# HOWE VALLEY LANDFILL SITE CORRESPONDENCE VOL III

Re: Howe Valley Landfill Hardin County, Kentucky Inorganic Contamination

Job No. 0064-001

DATE: 10/14/92	FIGURE 1	HATCHER-SAYRE, INC.
DRAWN BY: PDH	DETAIL FROM ORGANIC CONTAMINANT REMEDIATION PLAN DEPICTING	lexington, ky
APPROVED BY: JDK	THIRD AERATION TREATMENT ARKA	CLIENT NO.: 0084-001

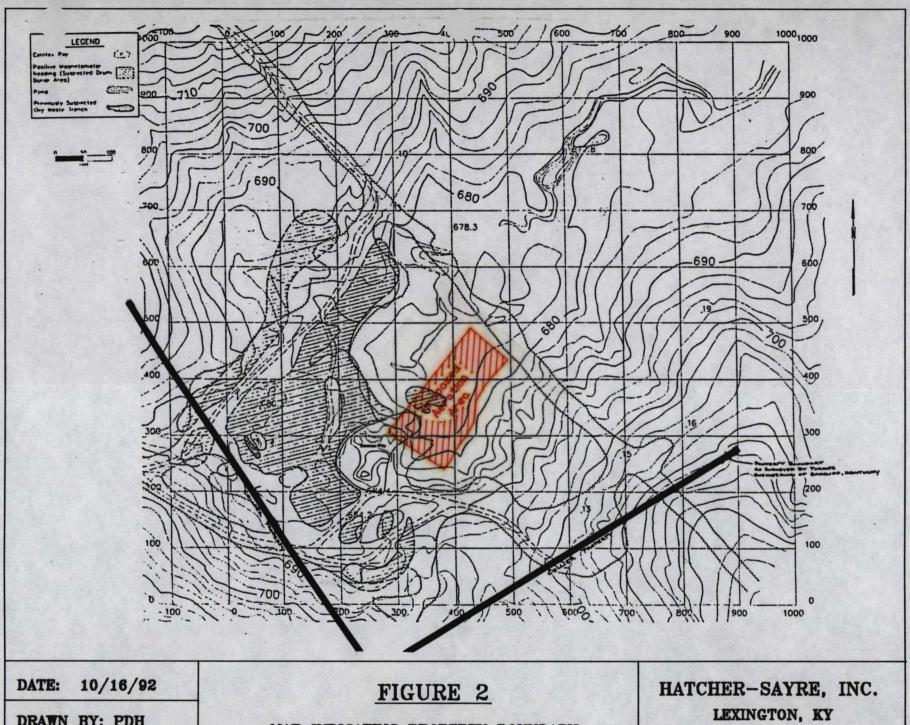
This situation has resulted in the need for an additional aeration area to expedite the drying and aeration of the soil. Therefore, a third aeration area is being proposed as indicated on Figure 1 (the affected portion of the Organic Contaminant Remediation Plan). This proposed third aeration area is situated near the central area of Dow Corning's property (see Figure 2). This area has only a thin layer of soil on top of the limestone bedrock and, as a result, at least 1 foot of fill material will be used to build it up. Additionally, since it is essentially on top of bedrock, a berm instead of a trench will have to be constructed around the area to divert precipitation run-on. Finally, as indicated on Figure 1, some of the small, second growth cedars and brush will have to be cleared during construction. No rare or endangered species are located in this area. Since time is of the essence, we are requesting approval on this proposed change as soon as possible. Upon approval, a second roto-tiller would also be brought onto the Site to expedite aeration.

DATE: 10/14/92	FIGURE 1	HATCHER-SAYRE, INC.
DRAWN BY: PDH	DETAIL FROM ORGANIC CONTAMINANT REMEDIATION PLAN DEPICTING	LEDINOTON, XY
APPROVED BY: JDK	THIRD AERATION TREATMENT AREA	CLIENT NO.: 0064-001

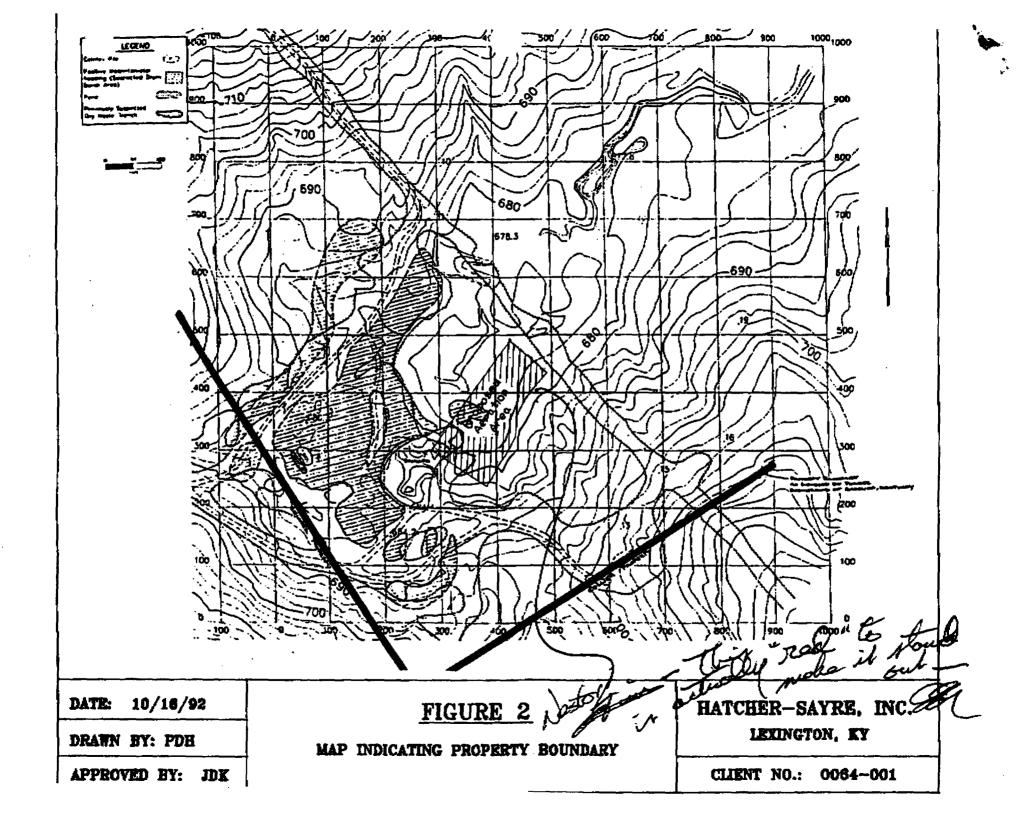
This situation has resulted in the need for an additional aeration area to expedite the drying and aeration of the soil. Therefore, a third aeration area is being proposed as indicated on Figure 1 (the affected portion of the Organic Contaminant Remediation Plan). This proposed third aeration area is situated near the central area of Dow Corning's property (see Figure 2). This area has only a thin layer of soil on top of the limestone bedrock and, as a result, at least 1 foot of fill material will be used to build it up. Additionally, since it is essentially on top of bedrock, a berm instead of a trench will have to be constructed around the area to divert precipitation run-on. Finally, as indicated on Figure 1, some of the small, second growth cedars and brush will have to be cleared during construction. No rare or endangered species are located in this area. Since time is of the essence, we are requesting approval on this proposed change as soon as possible. Upon approval, a second roto-tiller would also be brought onto the Site to expedite aeration.
